MODIFICATION DRAWINGS TO PROPOSED ALTERATIONS AND ADDITIONS
34 Pavilion Street - Queenscliff NSW 2096

DRAWING No:
MOD.01

MODIFICATION DRAWINGS TO PROPOSED ALTERATIONS AND ADDITIONS
34 Pavilion Street - Queenscliff NSW 2096
CLIENT:
Jan Beach
DRAWING TITLE:
NORTH AND SOUTH ELEVATIONS

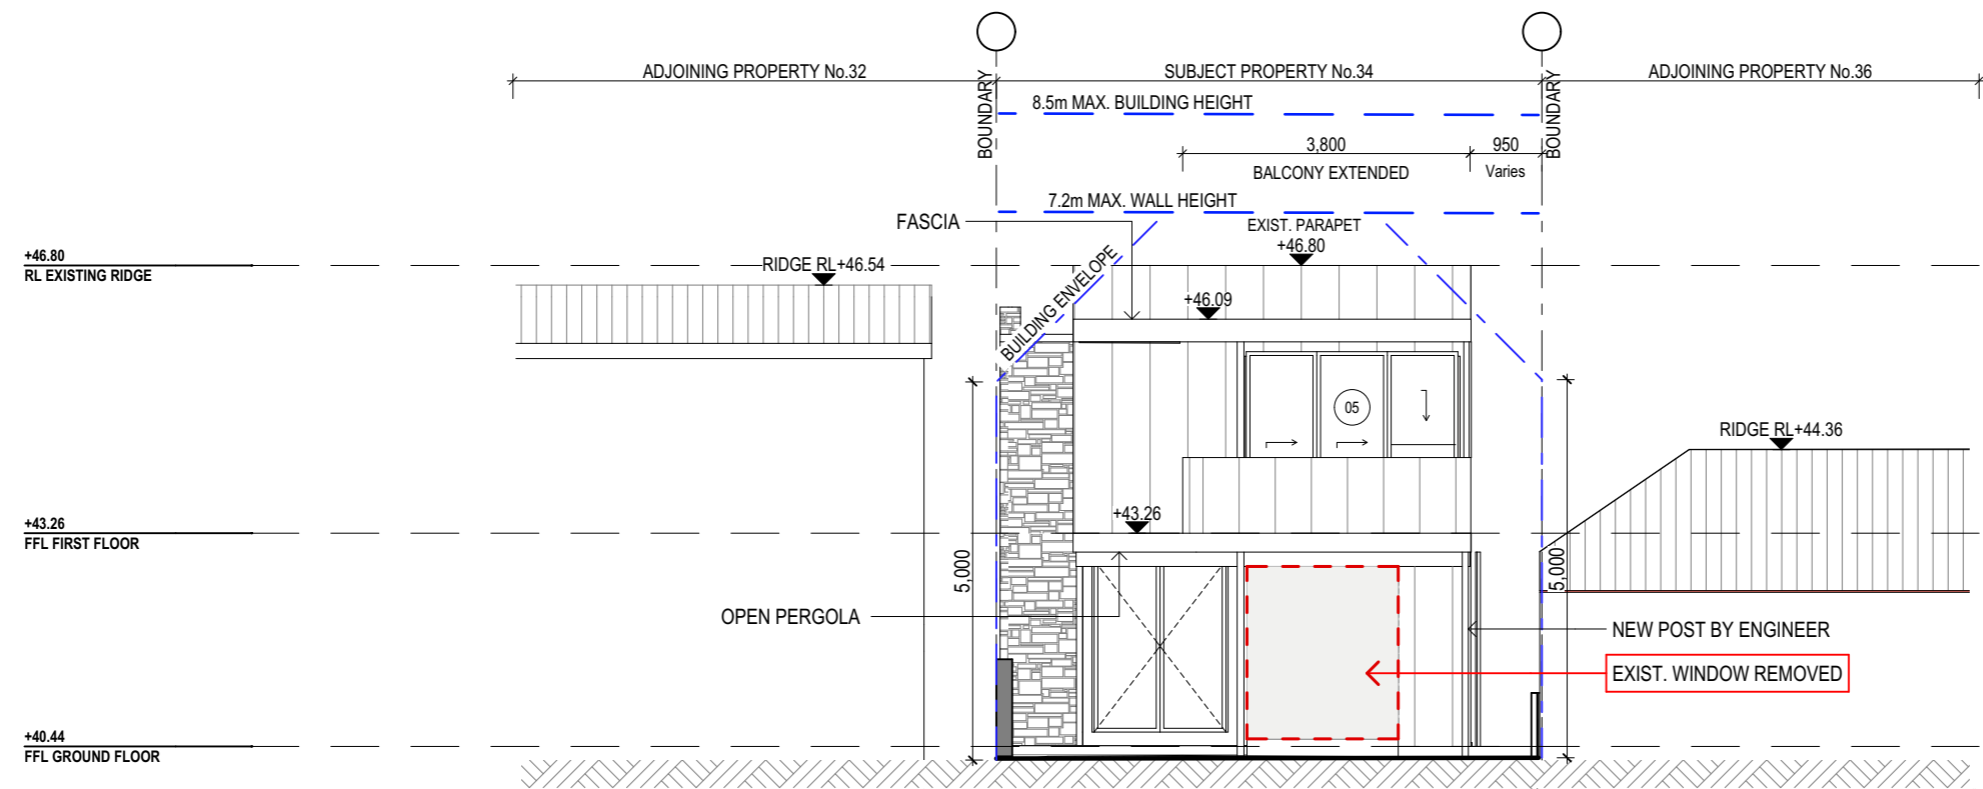
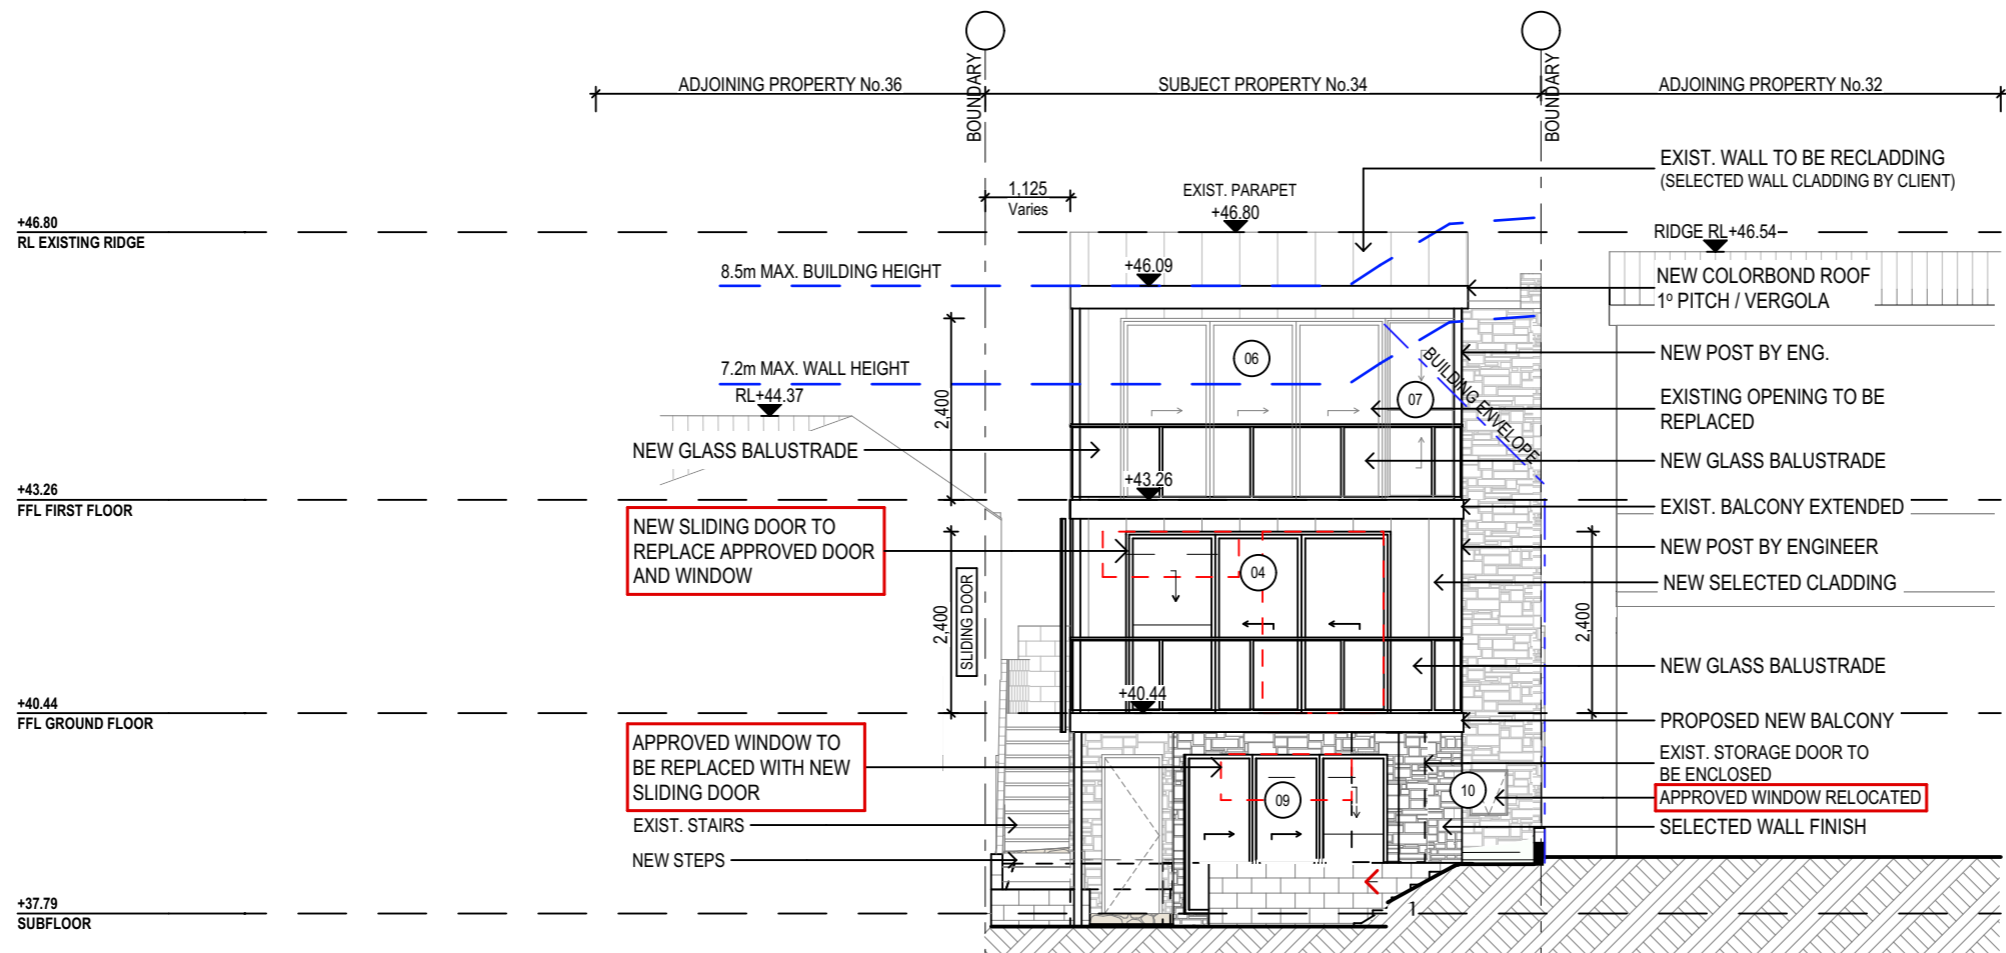
NOTE: CHANGES TO APPROVED
DA SHOWN IN RED

NOTE: MODIFICATIONS TO
APPROVED DA SHOWN IN RED

MODIFICATION DRAWINGS TO PROPOSED ALTERATIONS AND ADDITIONS 34 Pavilion Street - Queenscliff NSW 2096	
CLIENT: Jan Beach	
DRAWING TITLE: WEST ELEVATION

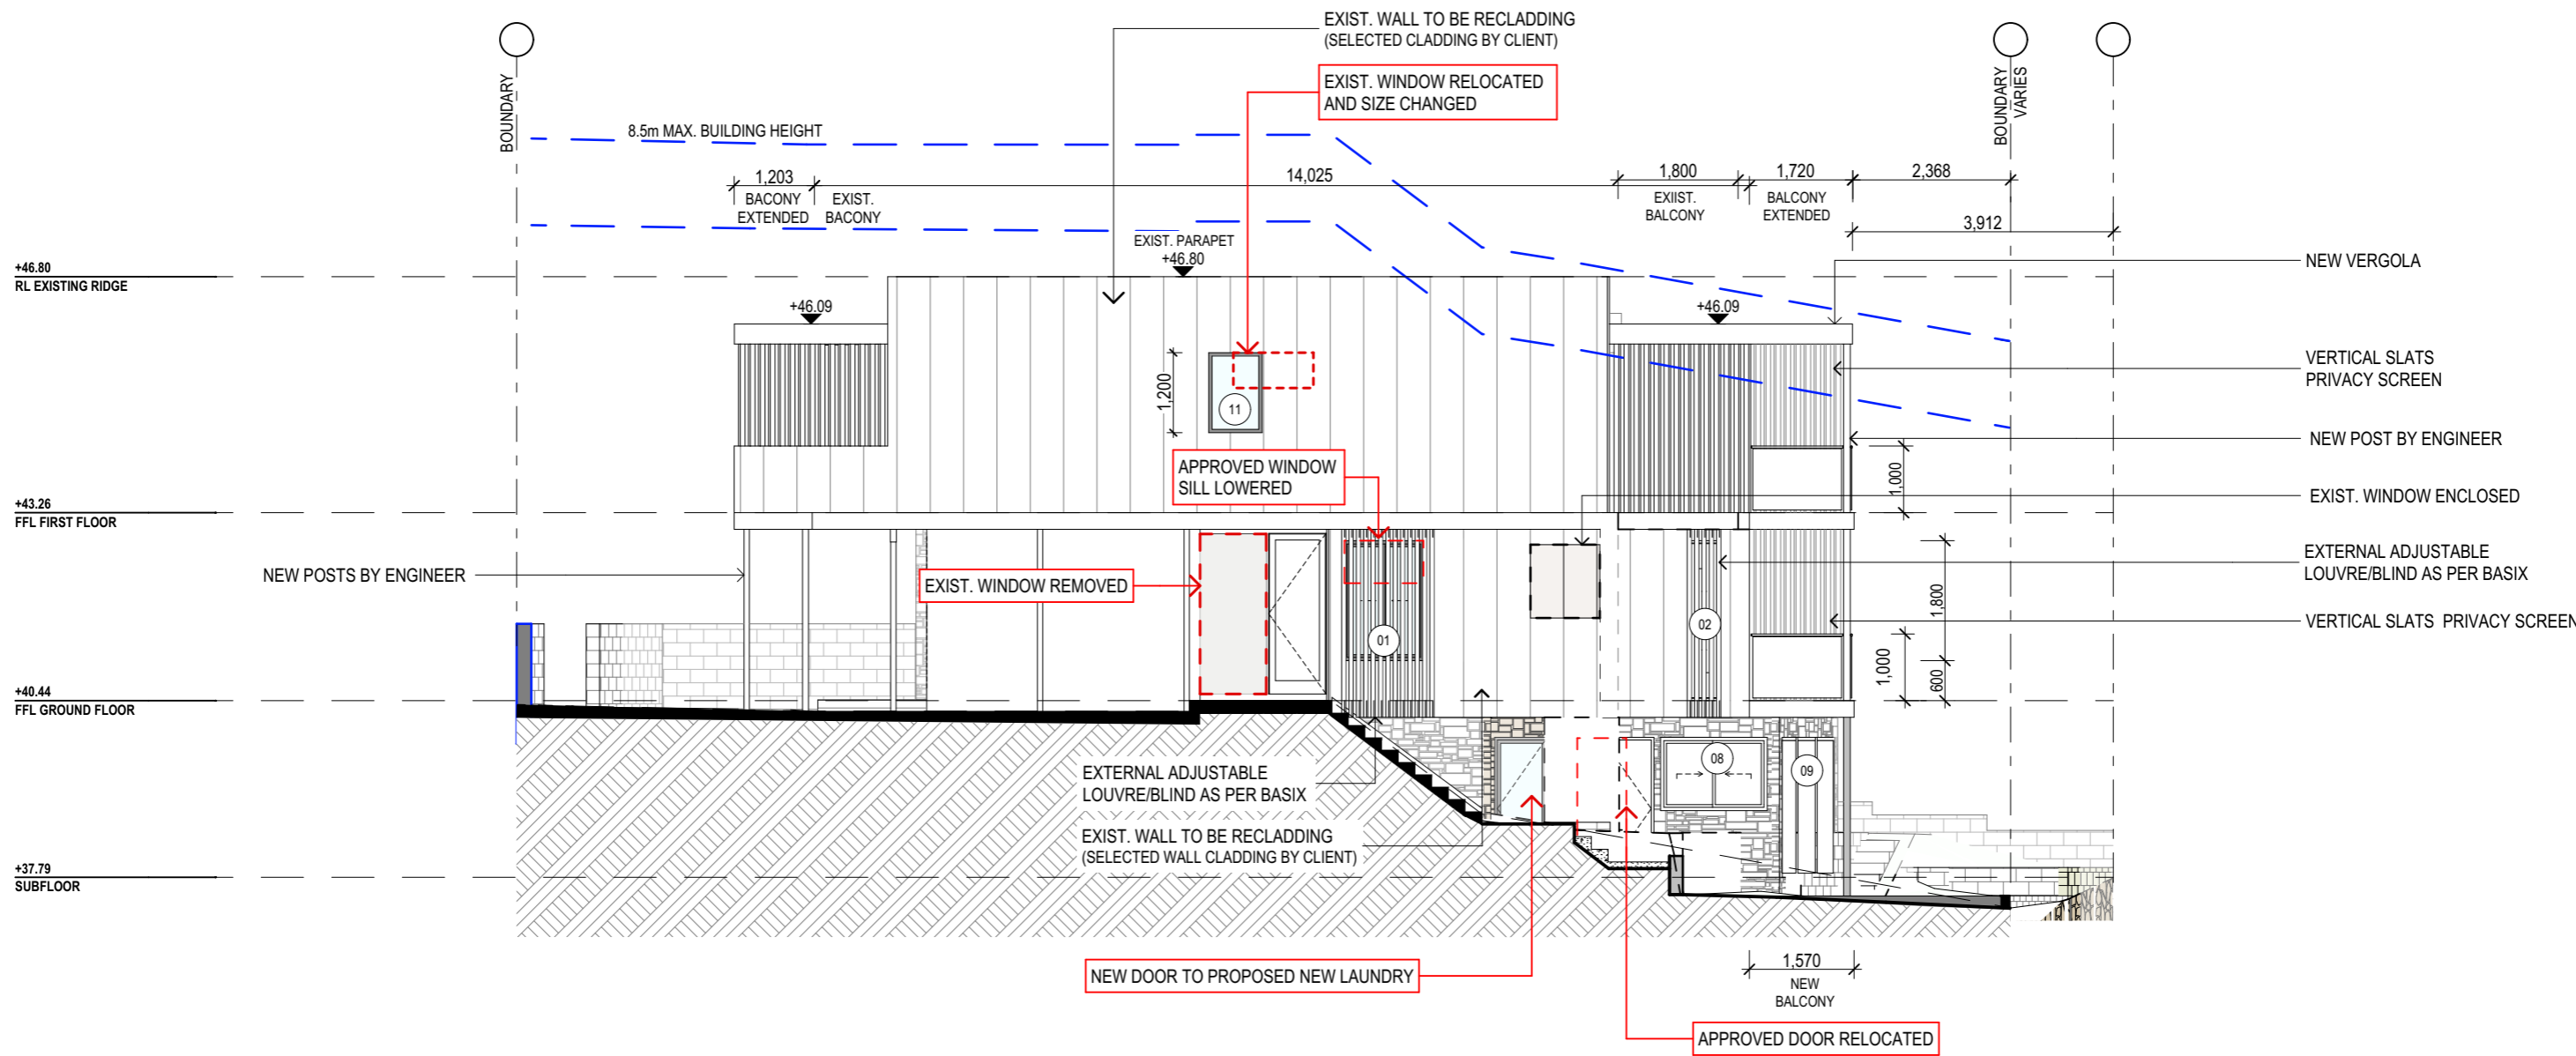
NOTE: MODIFICATIONS TO
APPROVED DA SHOWN IN RED
